From: Coleman, Heather <HColeman@sanleandro.org>
Sent: Wednesday, November 28, 2018 12:30 PM
To: Mogensen, Andrew; Stella, Michael; Chen, Reh-Lin; Richardson, Tonya; Barros, Sally; Benabou, Isaac; Braun, Melanie; Miraftab, Matin; Jenson, Justin; Fluehr, Yvonne
Cc: Detterman, Mark, Env. Health; Khatri, Paresh, Env. Health
Subject: RE: PLN18-0080 AR Cozy Nest Adult Day Care Transmittal - 2125 Williams St
Attachments: PLN18-0080 Submittal 2 Internal Dist Pkg 11.28.18.pdf

Subject: PLN18-0080 AR Cozy Nest Adult Day Care Transmittal - 2125 Williams St

Submittal #2
2125 Williams St. | Cozy Nest Adult Day Care
COMMENTS DUE Wednesday, December 12, 2018
DISTRIBUTION SHEET INTERDEPARTMENTAL DEVELOPMENT REVIEW

PROJECT **PLN18-0080**

1 NORTH ELEVATION
A311 1/8" = 1'-0"

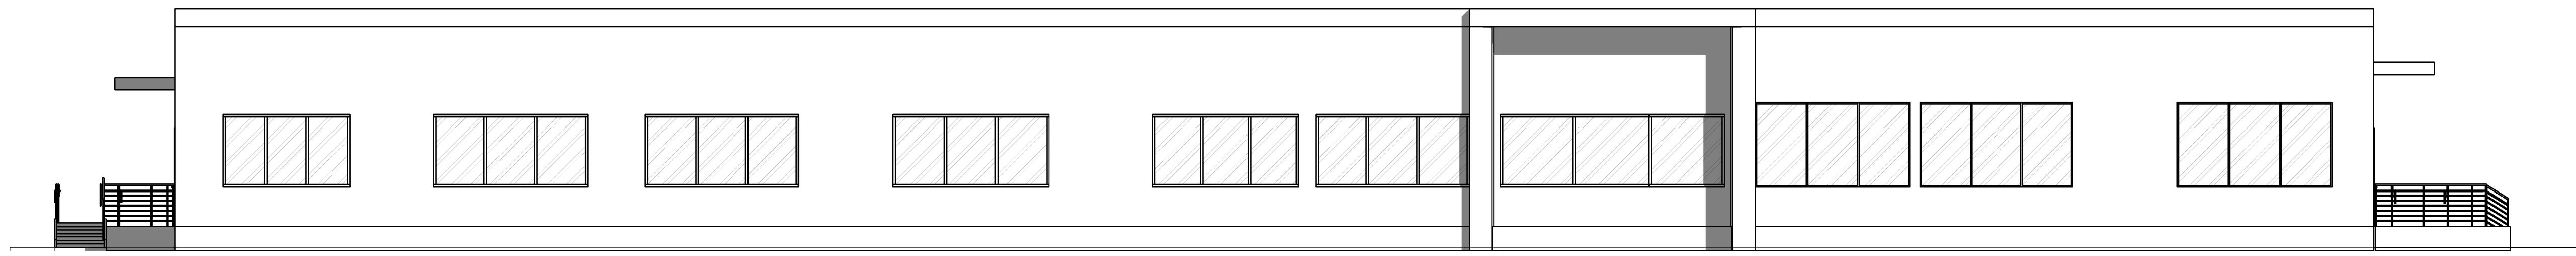
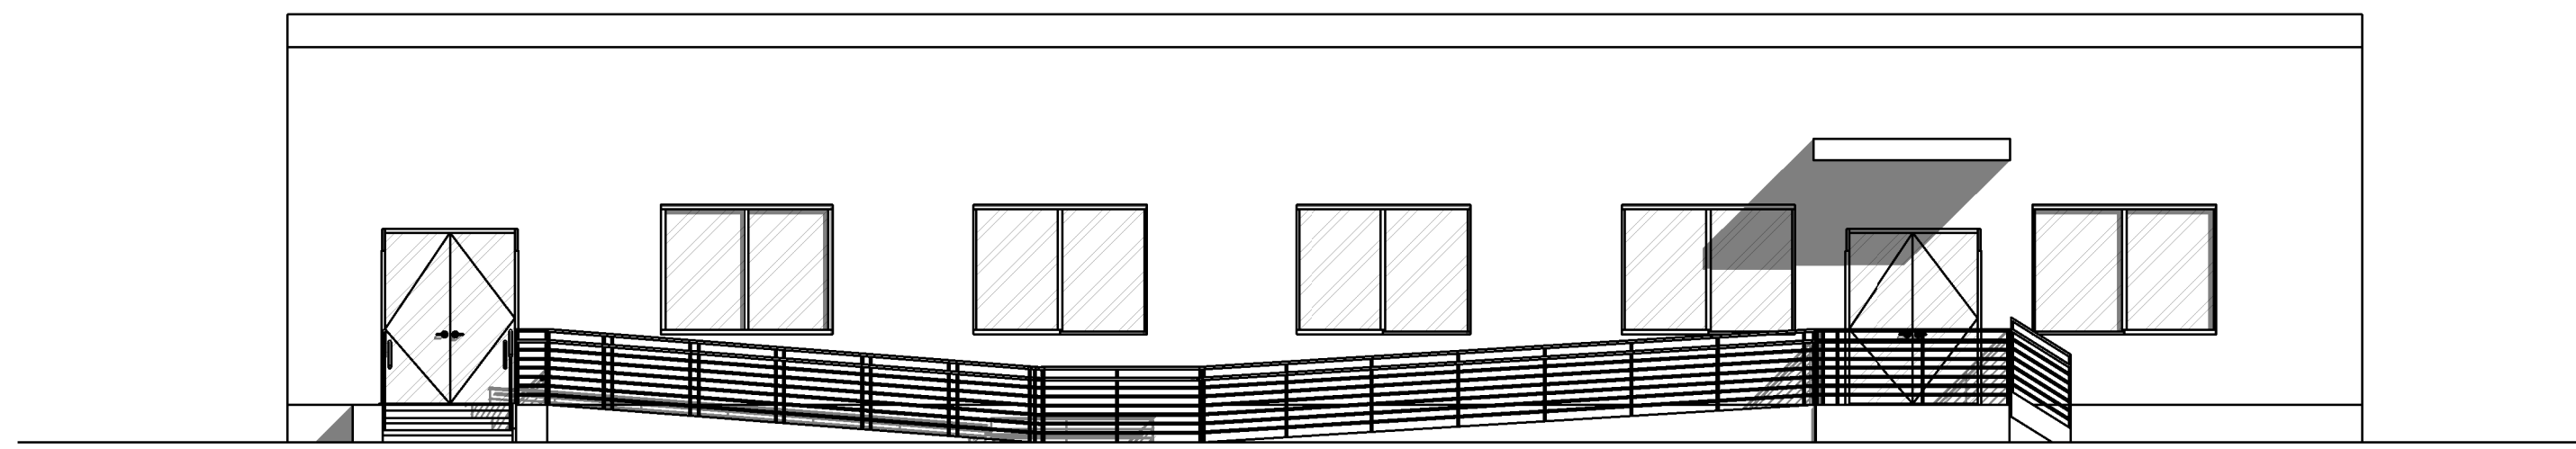
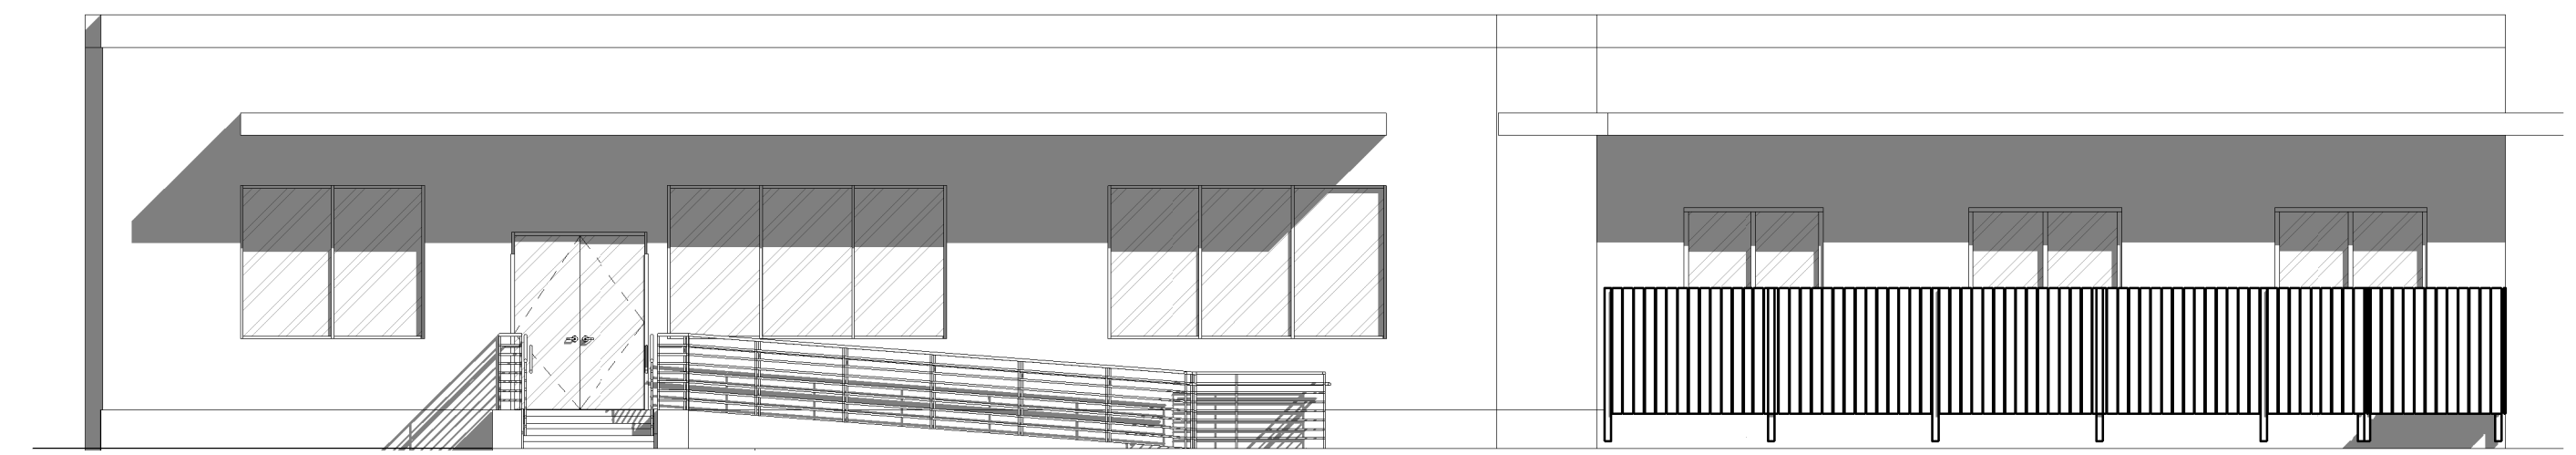
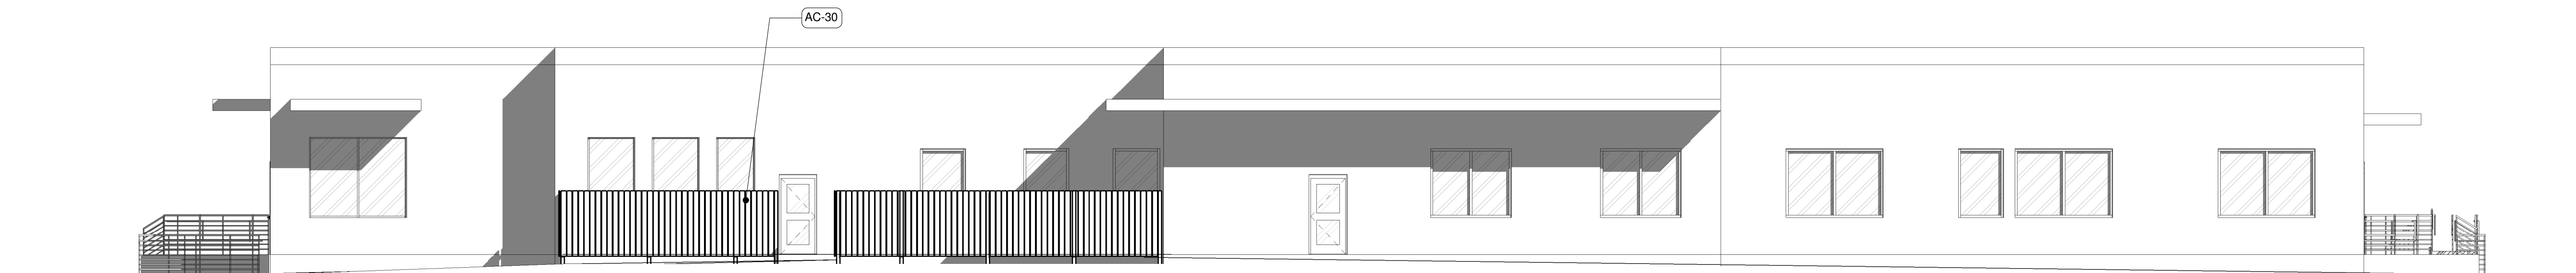
1. **Elevation Drawings.** Provide existing and proposed elevation drawings. (See the information sheet and submittal checklist for Administrative Review attached to this letter. Elevation drawings are typically required.) If certain elevations of the building will have no exterior changes, you may substitute photographs for elevation drawings of those sides of the building.

1. **Elevation Drawings.** There is NO change to Existing elevations for the proposed use. Existing Elevations have been added to Sheet A311. We are only adding a fence around the patio in the rear to create an outdoor gathering space for the seniors and that change has been clearly reflected in the floor plans and elevations.
